INVESTIGATION PROGRAM
Of Fillet Weld Size
On P-W- Industries Cable
Pan Hangers P.O. 7070-25102

WM. H. ZIMMER NUCLEAR POWER STATION PROJECT
THE CINCINNATI GAS & ELECTRIC CO.,
COLUMBUS AND SOUTHERN OHIO ELECTRIC CO., AND
THE DAYTON POWER AND LIGHT CO.

Subject: Deficient Welding of Cable Tray Hangers
"Investigation Program"

CINCINNATI GAS & ELECTRIC COMPANY WM. H. ZIMMER NUCLEAR POWER STATION			DESIGN DOCUMENT CHANGE DDC No. SLE 485 Page 1 of 3	
DWG/SPEC. NO. EB-117	REV.	ITEMIZATION NO. & SYSTEM:	DDC PREPARED BY: Martin E. Schuster Jr.	DATE: Sept. 21, 1979
DWG/SPEC. NAME:	DDC/SPEC. ISSUED BY:		DWG/SPEC. REGISTER NO. SLE #	DDC REGISTER NO.

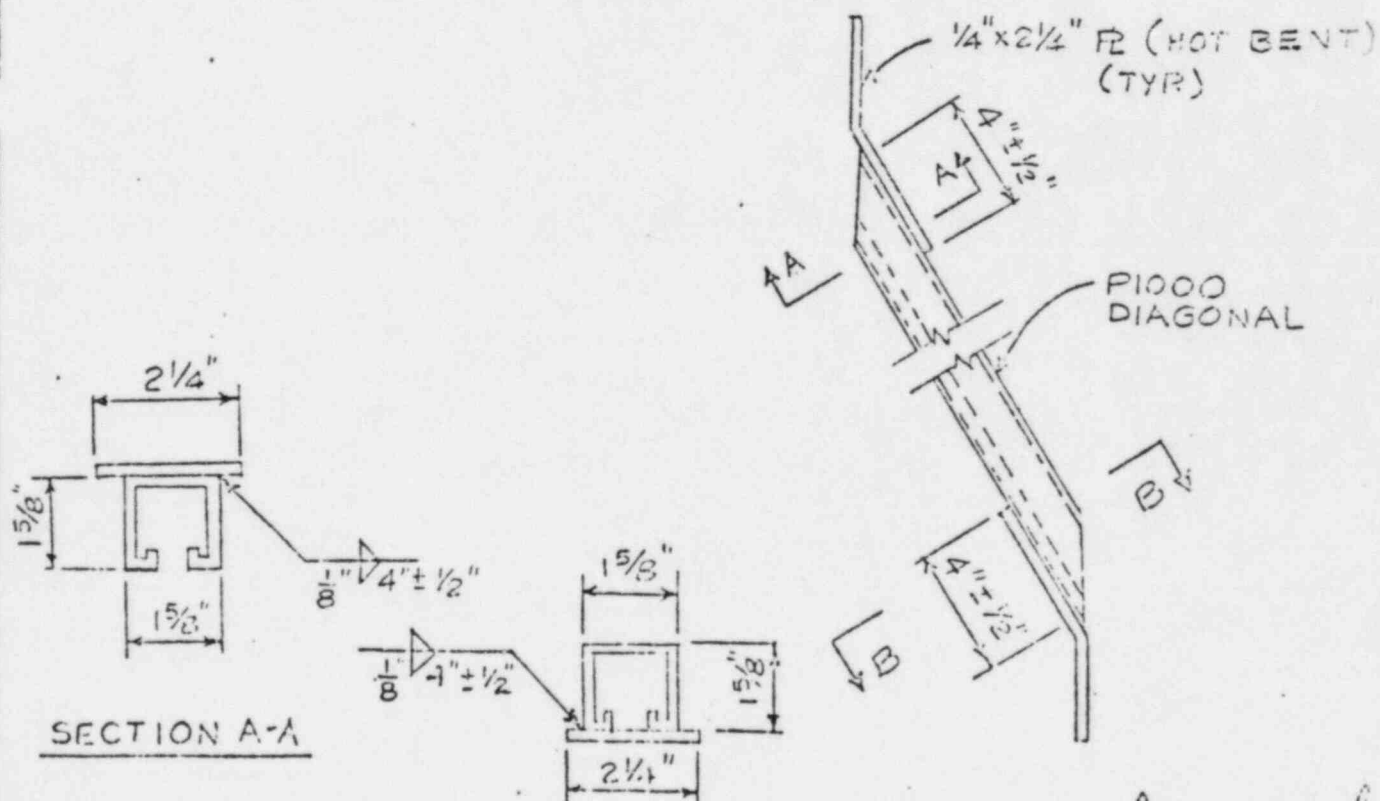
Cable Tray Hanger Tabulation Drawings refer to Standard Connection Details EB-117.12, 117.19, 117.20, 117.36, 117.60 & 117.68. These Standard Details show connection of hanger diagonal member to other hanger components. In many cases the 1/8" weld across the diagonal is missing and the 4" weld along the diagonal is no exactly 4" long.

Revise the connection between the diagonal and plate as shown below.

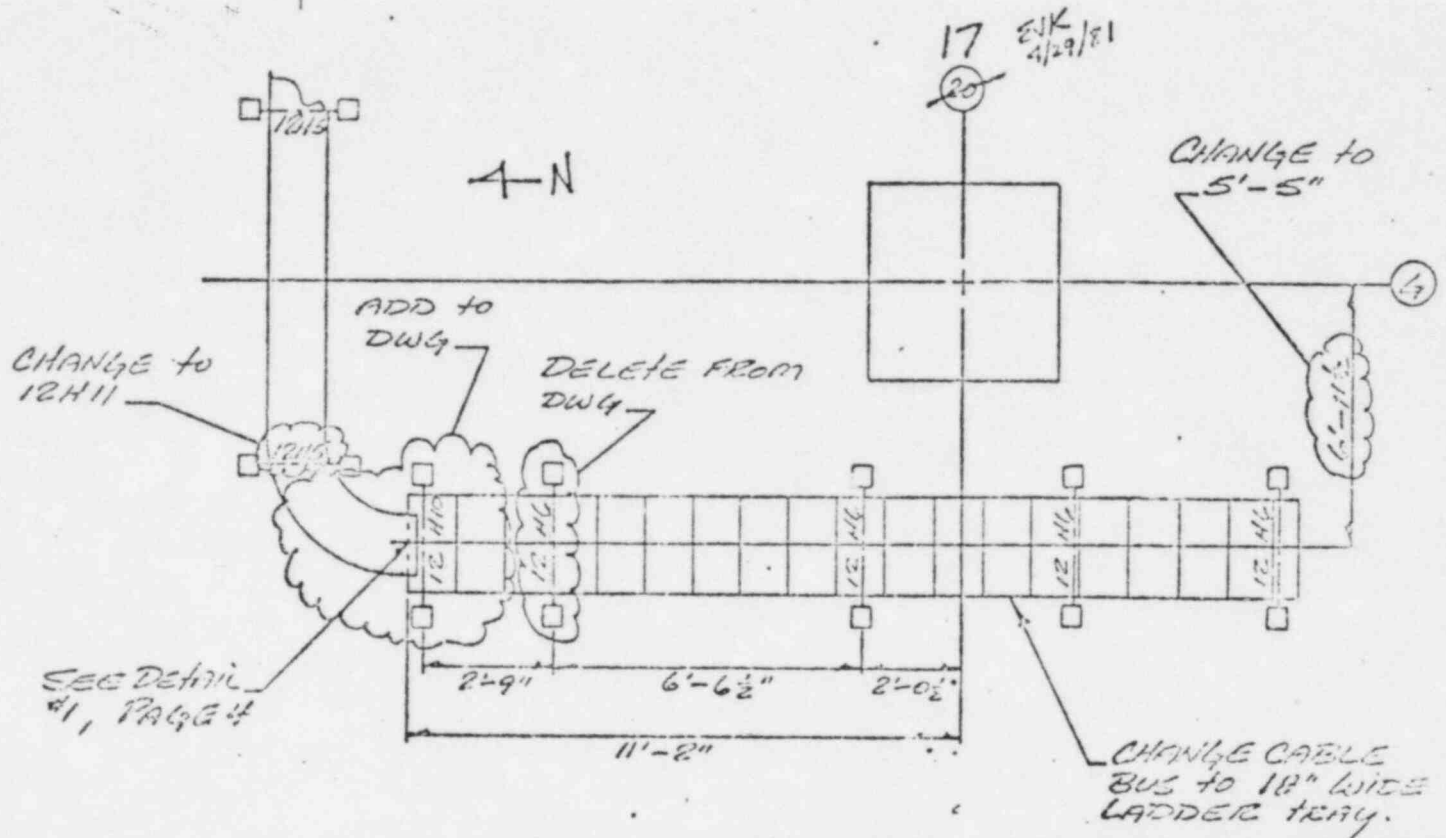
DEFICIENCY:	ACCEPT AS IS	
1) LADDER BOTTOM TRAY @ 6'-11" W OF G LINE IS INDICATED ON E-162 AS BUS		RELOCATED 2'-9" NORTH FOR CLEARANCE TO HIGH VOLTAGE CABLES WHICH EXIT THE TRAY AT THAT POINT.
2) THE LAST HANGER (H12H6) ON SAME TRAY IS INDICATED ON E-162 AS BEING 8'-7" H. OF E-17 A HANGER AT THIS LOCATION HAS BEEN REMOVED	REPAIR	SEE DETAIL #2, PAGE 4 FOR REPAIRS TO SIDE-RAIL FLANGE.
3) TRAY AT THIS POINT HAS BEEN

CHANGE DWG E-162 AS SHOWN. LADDER TRAY CONTAINS CABLES
 114, 115, 116 FROM CABLE BUS AND CABLES RR 153, 154 & 155.

DETAIL #1: CABLEBUS IS ATTACHED TO THE LADDER TRAY AS SHOWN.

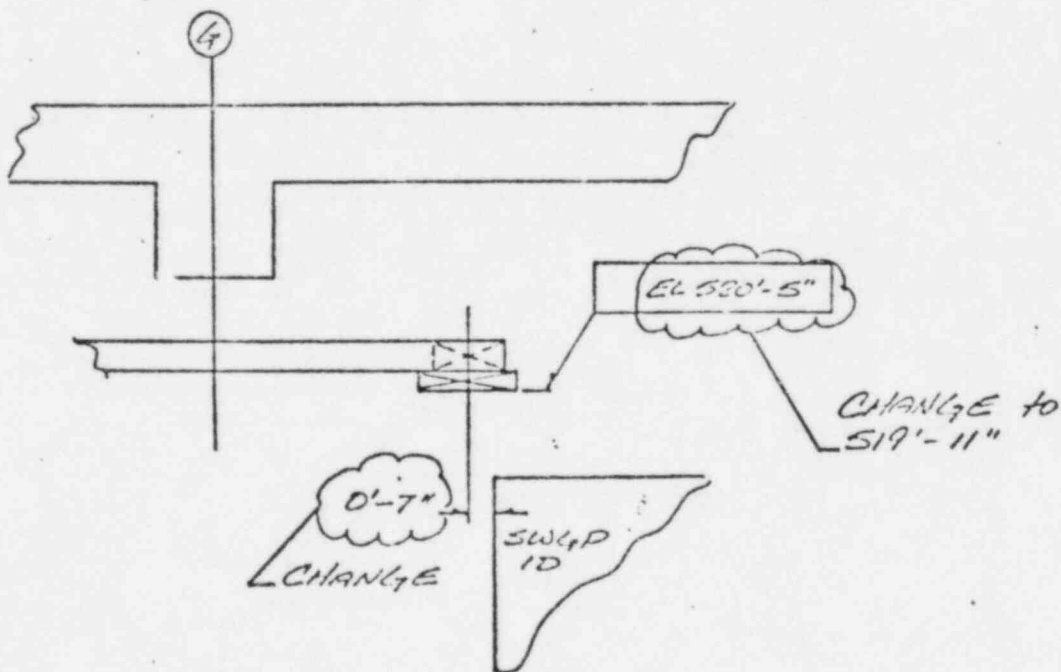
CHANGE DWG E-166 SEC RF AS SHOWN

SEC A-A

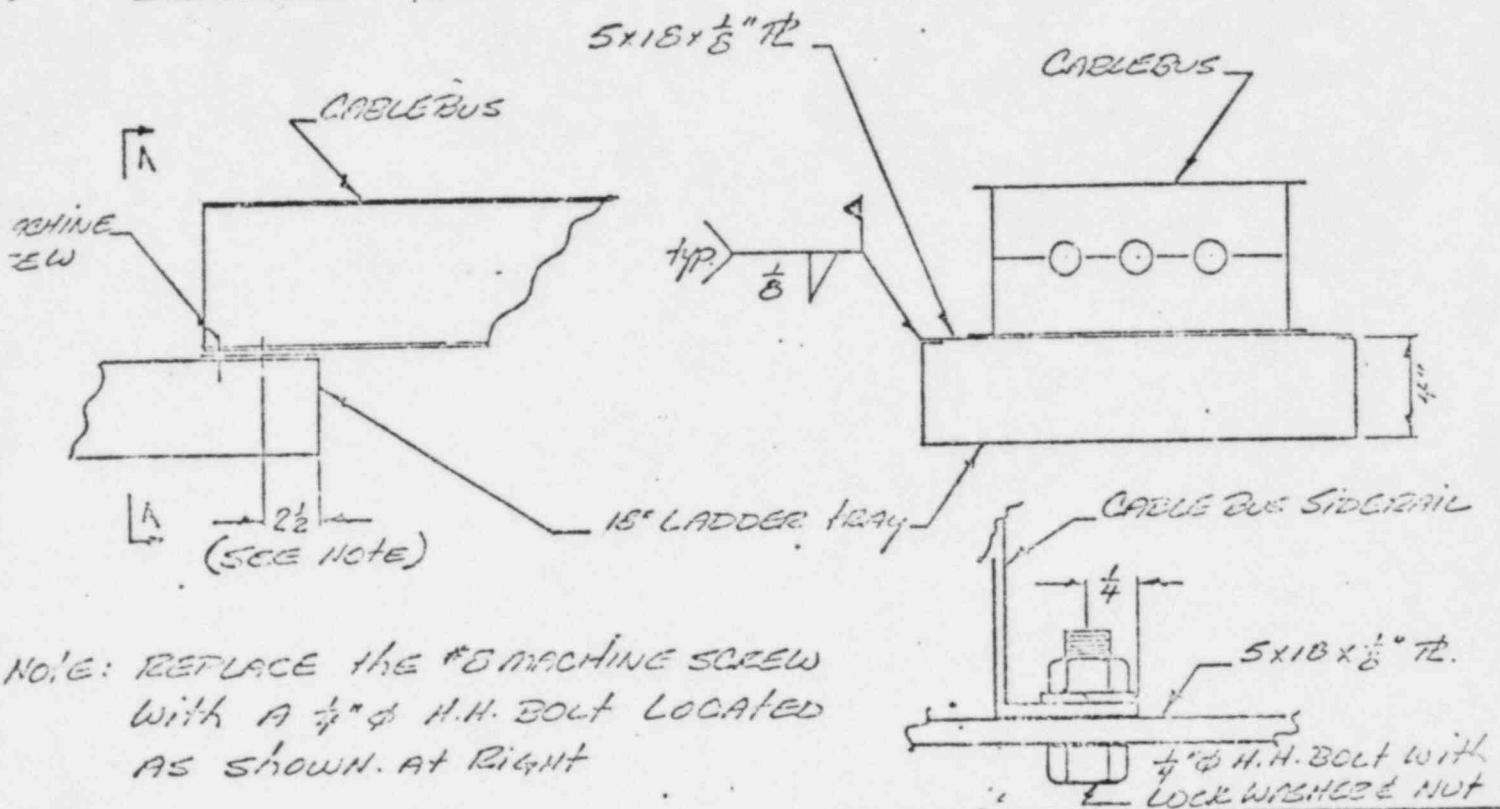
NOTE: REPLACE THE #8 MACHINE SCREW WITH A $\frac{1}{4}$ " ϕ H.H. BOLT LOCATED AS SHOWN. AT RIGHT

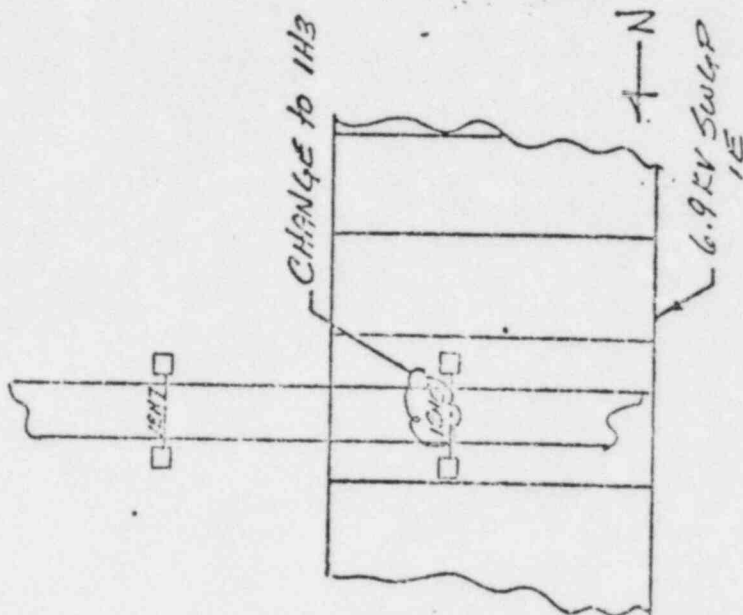
CHANGE DWG E-162 AS SHOWN.

* THE FOOT CONNECTION IS ATTACHED TO A SURFACE PLATE RATHER THAN AN EMBEDDED PLATE. AS SHOWN.

9x9x $\frac{1}{2}$ " PL ATTACHED WITH
FOUR $\frac{1}{2}$ " ϕ WEDGES AND NUTS
